Assessment report to Sydney Central City Planning Panel

Panel reference: 2018SWC002

DA number	SPP-17-00044	Date of lodgement	15 December 2017
Applicant	Stockland Development Pty Ltd c/o GLN Planning		
Owner	Woorong Park Pty Ltd and Stockland Development Pty Ltd		
Proposed development	Concept Plan comprising 945 residential lots within Stockland Precinct 6, including Stage 1 subdivision comprising 774 lots, roads and associated civil works		
Street address	Lots 1, 2 and 3 DP 1225885, Richmond Road Marsden Park		
Notification period	30 January to 1 March 2018	Number of submissions	0

Figure 2 - Overlay of road pattern

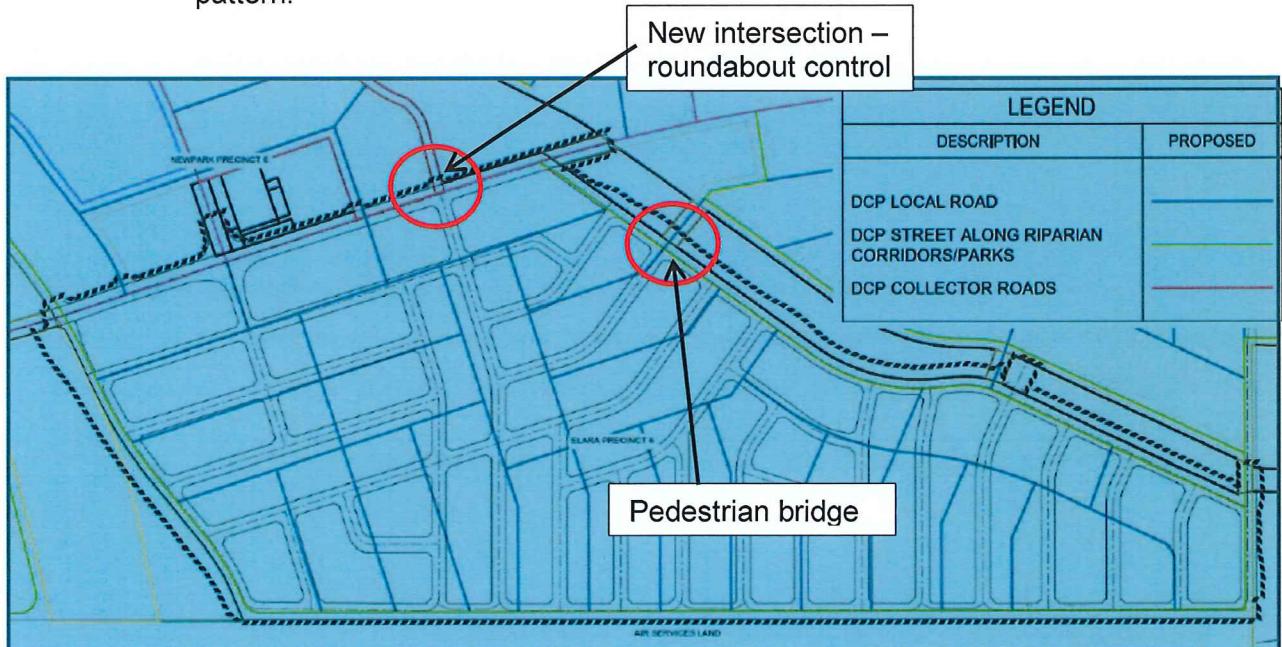
7.1.3 The applicant is seeking to vary the road pattern of the ILP. In support of the variation, the applicant has submitted an overlay showing the road network under the ILP and the proposed road network as shown in Figure 2 – Overlay of road pattern.

7.1.4 Following a detailed assessment, no objection is raised to the variations to the road pattern of the ILP for the following reasons:

- a. Council's Traffic Management Section has raised no objection to the amended road pattern subject to certain additional intersection control measures.

- b. The changes principally involve local roads and therefore are not considered to have any significant adverse impacts on the internal road network in terms of traffic efficiency or road safety.

- c. The road pattern would achieve a permeable layout to facilitate vehicle and pedestrian movements, maximises surveillance over the drainage corridors and does not include culs-de-sac.

- d. The proposal includes changes to the Southern Perimeter Road that adjoins the Air Services land, aiming to prevent this road to be used as a long through road.

- e. The proposal is consistent with the road hierarchy stipulated in Figure 4-2, Schedule 6 Marsden Park Precinct DCP.
- f. The locations and alignments of all the proposed roads will not impede connectivity and accessibility with surrounding development, particularly to the north, west and east.

- g. The overlay received by Council has demonstrated that the road area now proposed is greater than the road area under the adopted ILP and therefore the proposed variation will not increase the potential dwelling yield.

- h. The variation to the road layout will not impact on the minimum residential density required. The proposed subdivision will achieve the minimum dwelling density as required under the SEPP.

Figure 3 - Extract from Plan No 11035003/DA07 showing cross junction intersection at Road 602/Road 100/Road C3

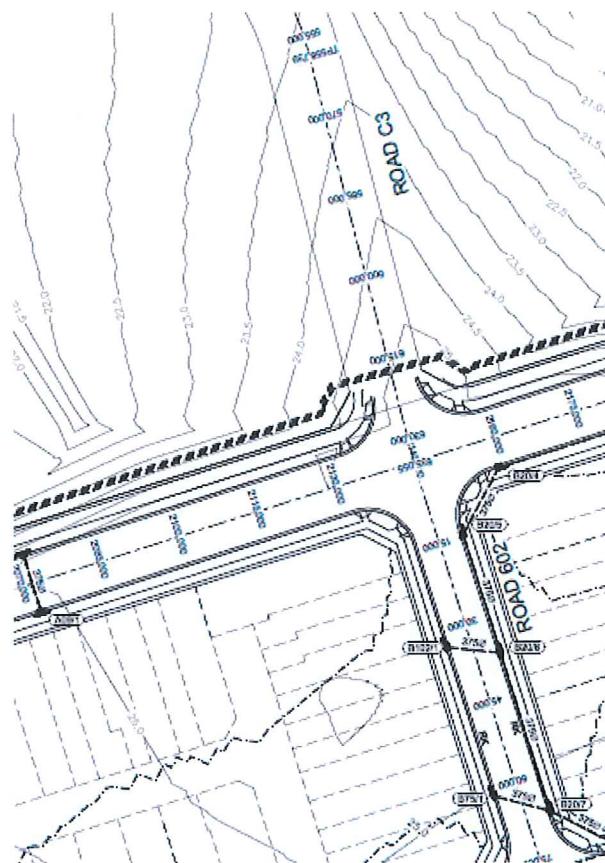
7.2.1 The applicant initially proposed a give way control on the intersection of the main collector road (Road 100), Road C3 and a local road (Road 602) (see Figure 3 below). Council's Traffic Management Section did not agree and suggested a roundabout for this intersection as Road 602 is expected to function as the main feeder road. The applicant then suggested a central median. However, this solution was also not acceptable and the applicant has now amended the proposal to include a roundabout at this intersection.

7.2.3 Council's Traffic Management Section has advised that the concept of the roundabout design is acceptable. However, this may have some implications for proposed development to the north in Precinct 5 in an earlier approval. It is recommended that Deferred Commencement Consent be granted requiring a detailed design of the roundabout and assessment of the impact on the adjoining development to the north in Precinct 5. Should any changes to the layout or lot configuration be required for the approved Precinct 5 development, the applicant will have to lodge separate modification applications for Council's consideration and determination to vary that consent.
